# Access Compliance Report

## Public Rights-of-Way

Intersection ID: 21789	Main Street: THORNCLIFF_DR	Cross Street: WOODSTOCK_DR	Location: E
ADA ID: C4AE6ACF7E61	Ramp Type: PerpDiag	Initial Pass/Fail: Fail	Overall Compliance: No
			Severity Score: 46.25

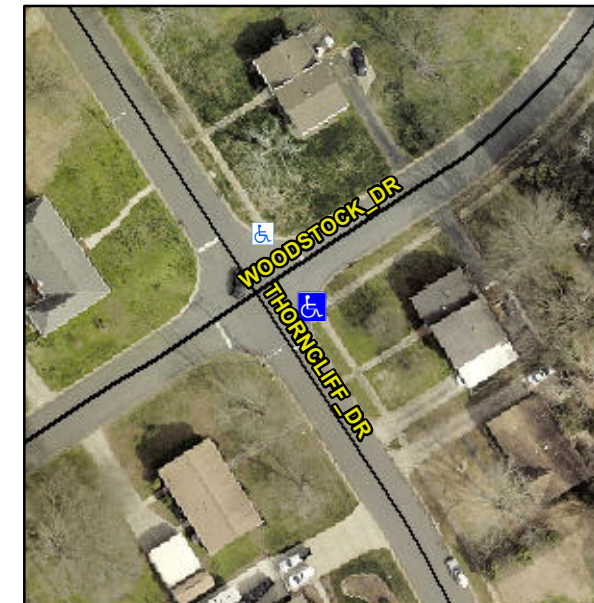
**Not Found, R304.5.1, R304.2.2, R304.5.3**

Compliance	Description	Data	Compliance	Description	Data
N/A	Ramp Length (in)	64.0	No	Ramp Slope (%)	15.3
No	Ramp Width (in)	43.0	No	Ramp XSlope (%)	5.7
N/A	Flare Type LT	N/A	N/A	Flare Type RT	N/A
N/A	Flare Slope LT (%)	N/A	N/A	Flare Slope RT (%)	N/A
N/A	Flare Traversable LT?	N/A	N/A	Flare Traversable RT?	N/A
N/A	Landing Length (in)	N/A	N/A	DWS Provided?	N/A
N/A	Landing Width (in)	N/A	N/A	DWS Contrast?	N/A
N/A	Landing Slope (%)	N/A	N/A	DWS Length (in)	N/A
N/A	Landing X Slope (%)	N/A	N/A	DWS Full Width?	N/A
N/A	Landing Curb? (Y/N)	N/A	N/A	DWS Offset (in)	N/A
N/A	Shared Landing?	N/A			
N/A	Gutter Ponding?	N/A	N/A	Gutter Slope (%)	N/A
N/A	Gutter Lip Ht (in)	N/A	N/A	Gutter X Slope (%)	N/A
N/A	Painted X Walk1?	No	N/A	Painted X Walk2?	No
	X Walk 1 Direction	To NW		X Walk 2 Direction	To SW
N/A	X Walk 1 Width (in)	N/A	N/A	X Walk 2 Width (in)	N/A
	X Walk 1 Slope (%)	6.9		X Walk 2 Slope (%)	5.3
	X Walk 1 X Slope (%)	1.3		X Walk 2 X Slope (%)	5.8

**Remove & Replace Curb Ramp With Two New Directional Ramps or Equivalent.**
